RESPONSES TO NFUCG COMMENTS AS LISTED IN THEIR “SUMMARY OF KEY CONCERNS” OF JULY 1, 2016

The following comments were submitted initially on May 27, 2016, and attached to the comments submitted on July 1, 2016, as “Appendix A”:

Figure 1. Current 2009 UFA Residuals, Keystone Heights and Surrounding Areas

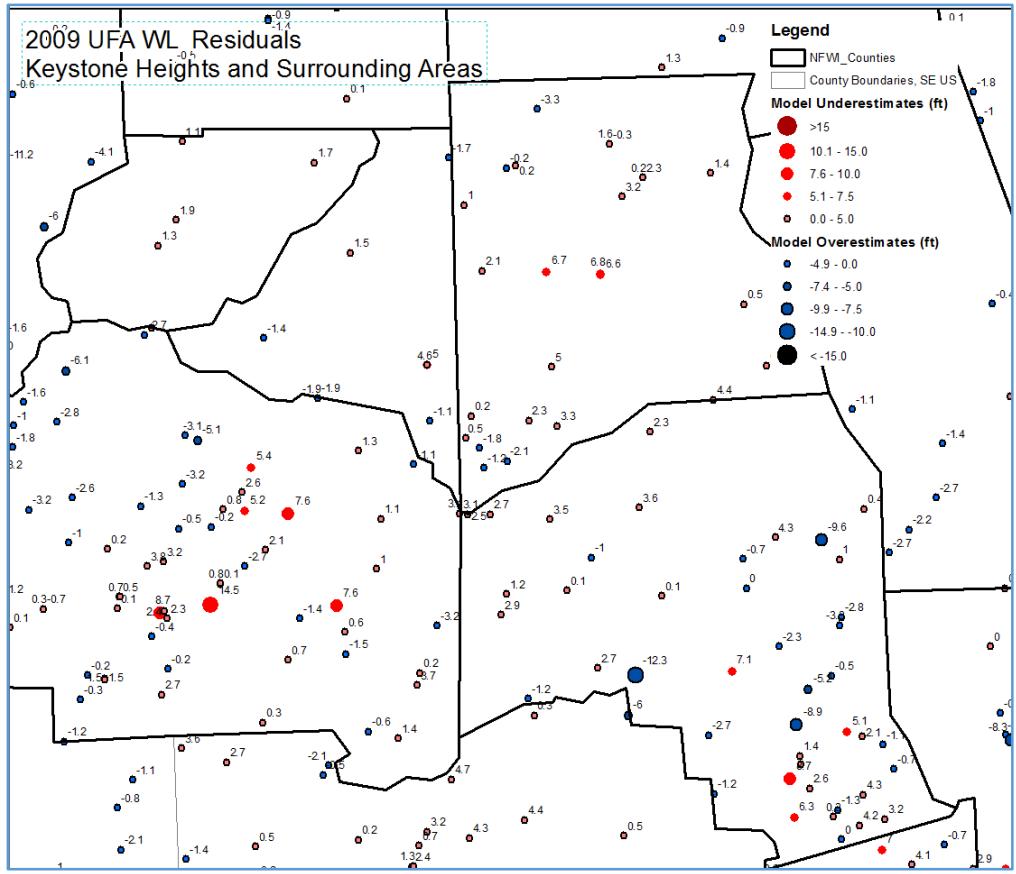
The NFSEG MODFLOW model has several areas in the NFRWSP region that appear to uniformly (or almost uniformly) overpredict or underpredict the UFA potentiometric surface by more than average. As shown in Figure A7, we note areas in Union, Bradford, Baker, Columbia and Clay Counties, and Putnam and Volusia Counties as having underpredicted potentiometric levels. While an area in Alachua County has overpredicted potentiometric levels. We would request that the Districts further evaluate these areas to improve the calibration.

Please explain how the Keystone Heights region was calibrated in the MODFLOW model. Specifically, how were lake levels (or levels/conductances/fluxes at lake boundary conditions), creek flows, and the surficial aquifer calibrated (e.g., what parameters were varied, what data were used, etc.)?

The relatively large aquifer-layer-3 water-level residuals in areas of the model domain that correspond to Union and Alachua counties have been reduced to within an acceptable range (Figure 1). We achieved this by increasing the weights of these observations, and/or by adjusting the bounds of hydraulic conductivity of nearby pilot points in the PEST-calibration process.

Modification of the calibration process to address isolated instances of water-level residuals in excess of 5 feet, such as those corresponding to parts of Putnam and Volusia counties, may result in ‘over-fitting’, which can have a negative effect on the predictive capabilities of the model. Therefore, we did not attempt to address residuals in the parts of the model domain corresponding to areas outside of Alachua and Union counties, as the referenced residuals corresponding to those areas appear to be isolated in nature and therefore are not indicative of widespread problems.

Lake levels, which are represented with river-package boundary conditions, are fixed, not simulated. No base-flow estimate was available for Alligator Creek, so no matching of simulated to estimated base flow was performed. The primary observation group for this area is aquifer water level, both surficial and Upper Floridan, and lake leakage rates. Leakage rates between the major lakes in this area and the groundwater system were estimated using data obtained from numerous past studies, and the simulated rates determined using river-package boundary conditions were extracted and compared with these estimates. We were able to match observed groundwater levels very well. Simulated lake leakage rates fall within the expected range of estimated lake leakage rates (Figure 1 and Table 1).

Figure 2. HSPF-Derived NFSEG Recharge Distribution, 2001

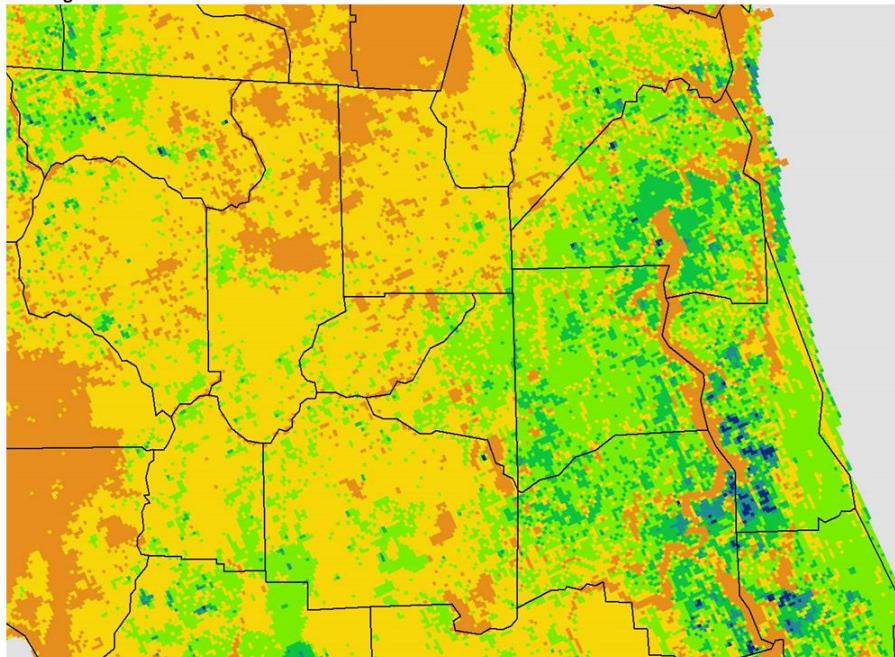
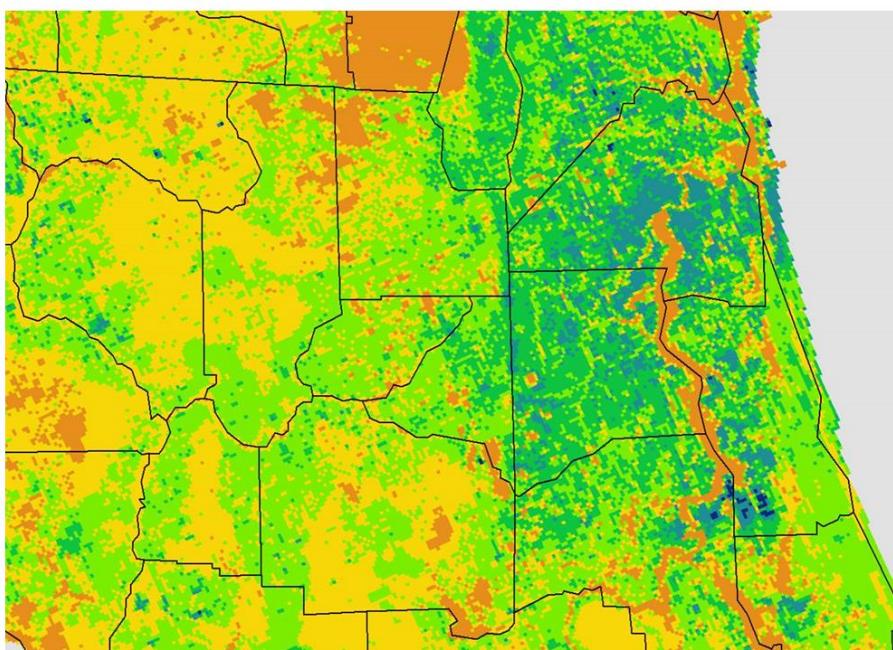
Recharge to MODFLOW is derived as an output from the HSPF models. In our review of MODFLOW recharge input, significant discontinuities in recharge occur in some locations along HSPF model boundaries. As shown in Figure A10 and Figure A11, one such area is in Union and Bradford Counties where the Lower St. Johns River, St. Mary's River and Santa Fe River HSPF models converge. Please explain the differences in MODFLOW recharge in this area.

The problems with the HSPF models that you are referring to were corrected. Noticeable discontinuities in the recharge distributions have now been minimized or eliminated (Figure 2 and Figure 3). Please review the responses to the HSPF comments for details.
